Botley West Solar Farm

Environmental Statement Addendum 2

Document Ref: EN010147/APP/20.2

Scale: 1:7500 at A0
Title: Change Process Plan - Project Amendments since Submission highlighting Application of Mitigation Hierarchy Northern Part

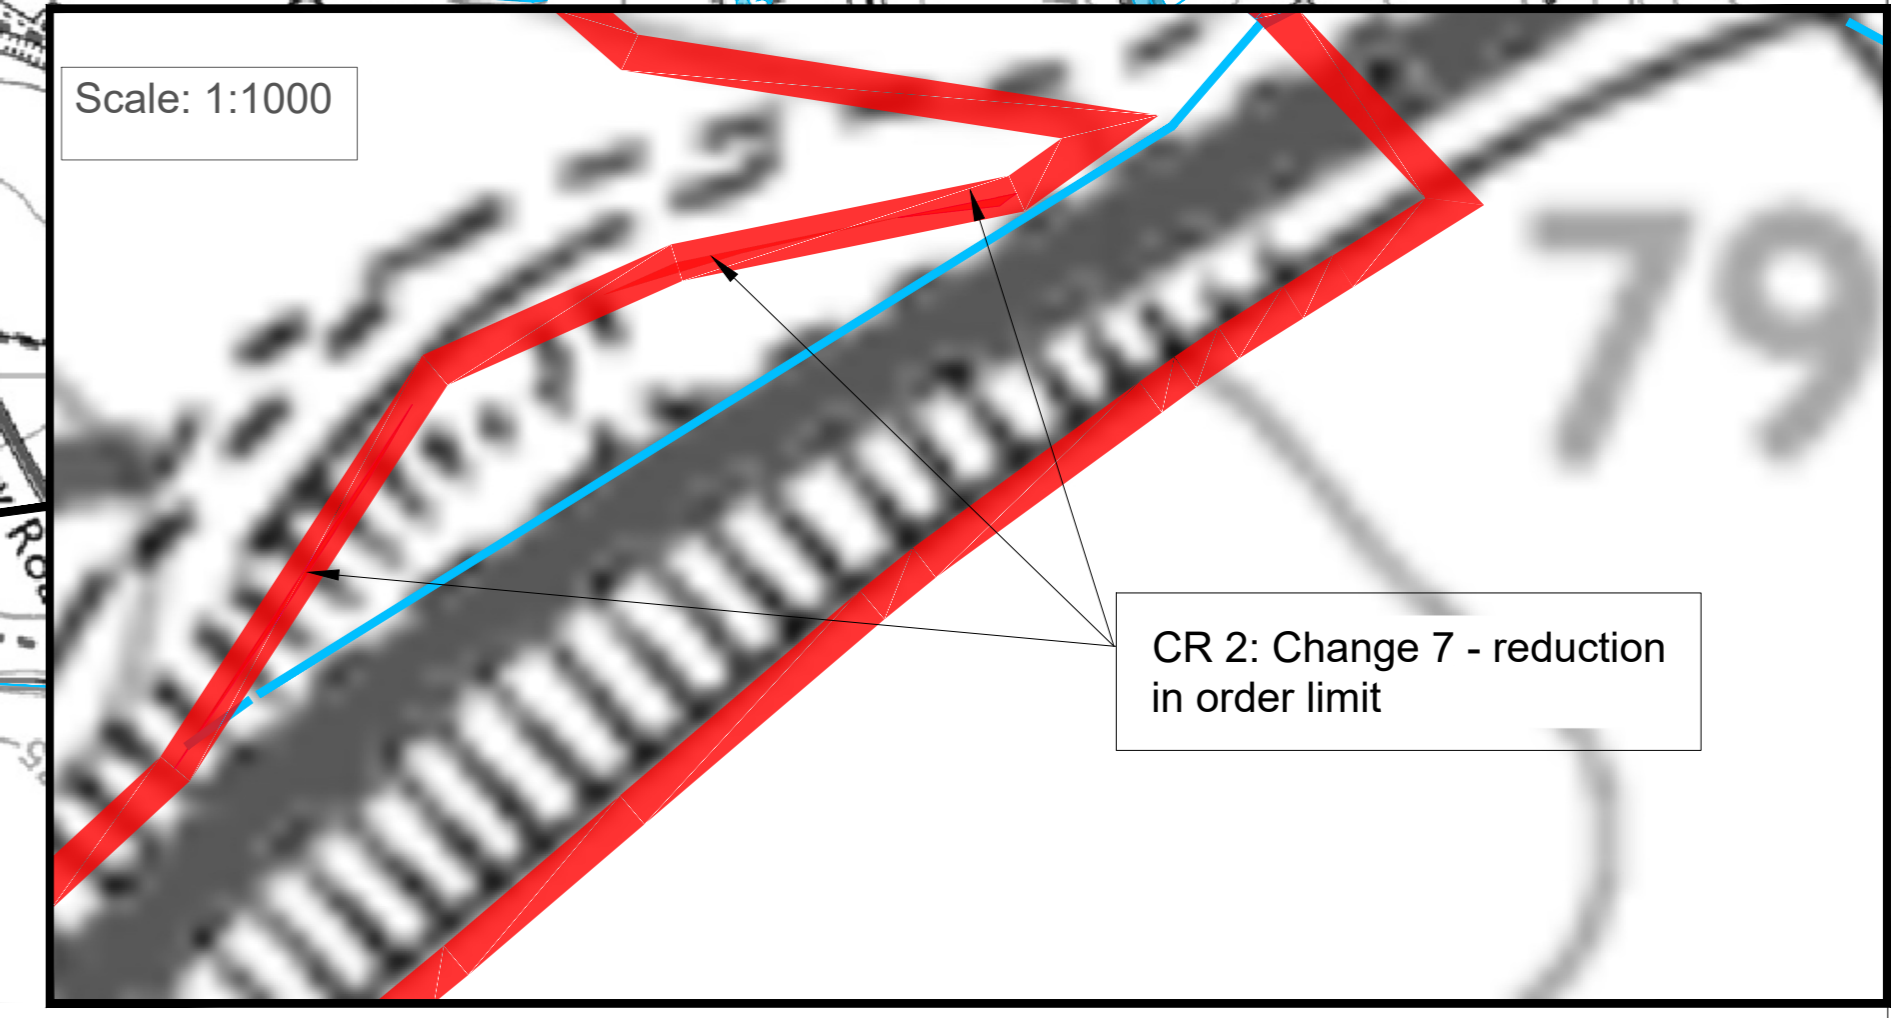
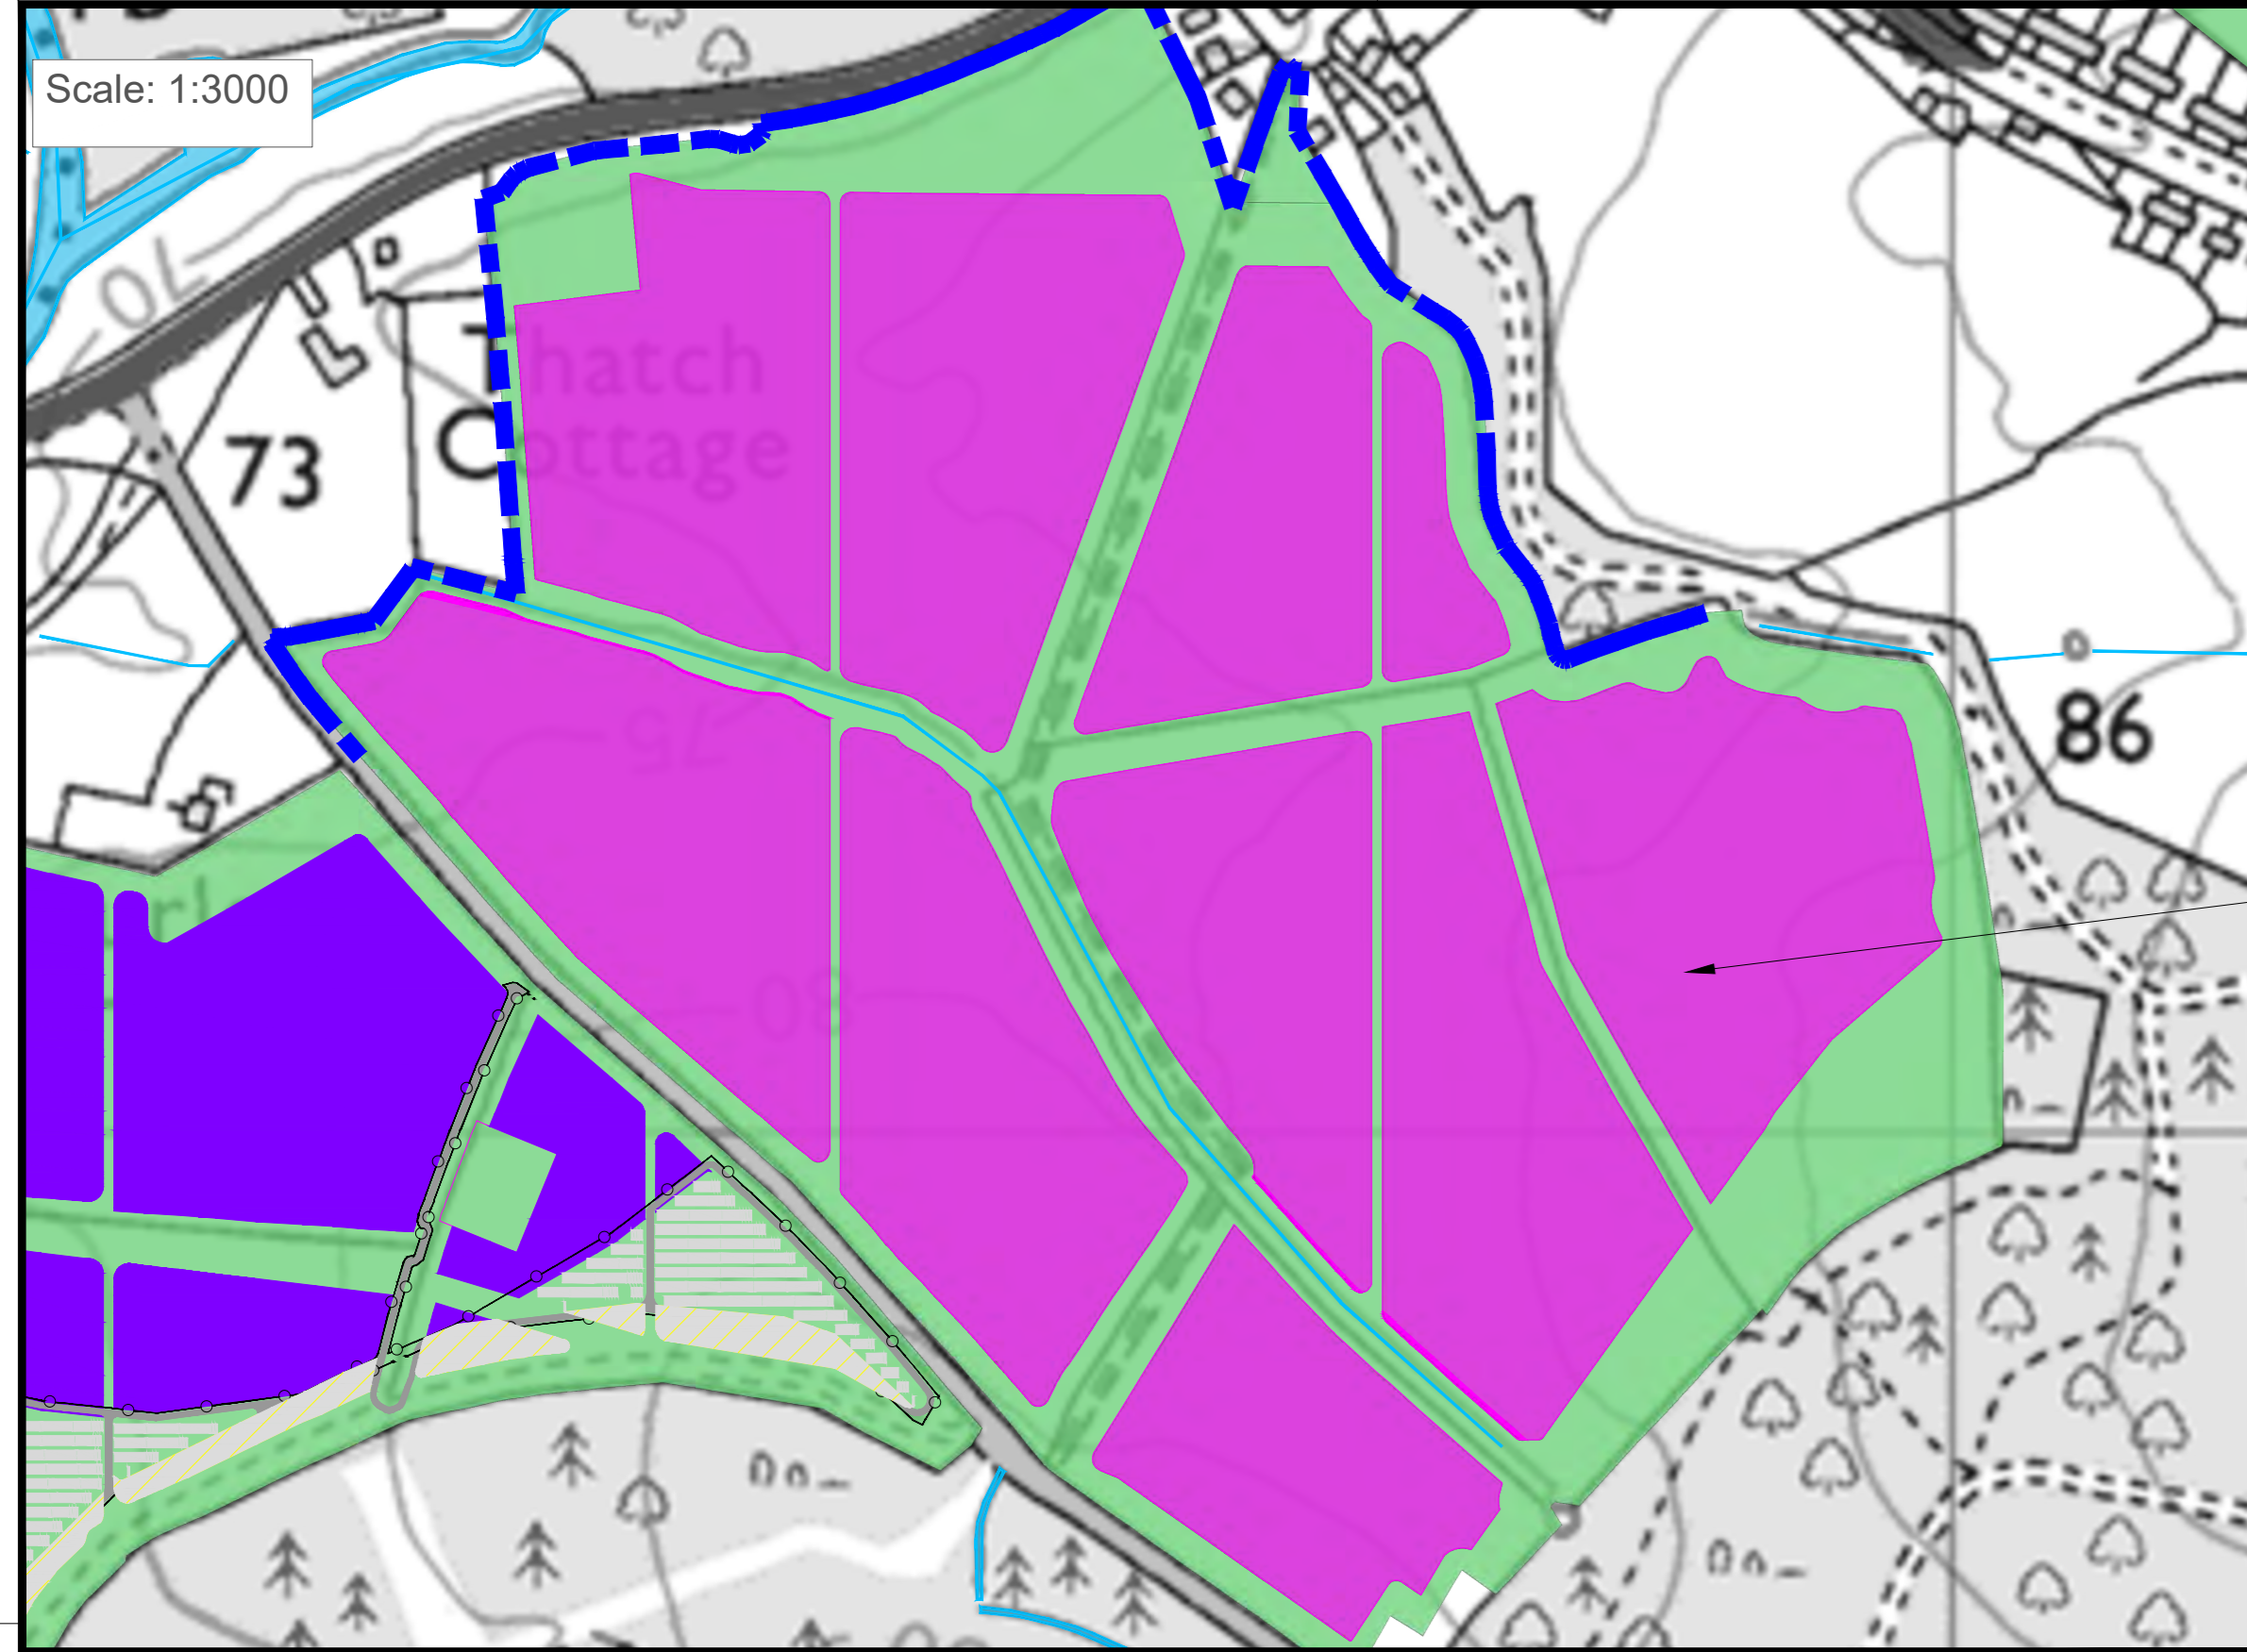
250m buffer
Removal of solar installation area for bat corridor

CR 2: Change 5 - Removal of solar installation area to increase buffer to water course

Removal of solar installation area for further archaeological protection and management

CR 2: Change 7 - reduction in order limit
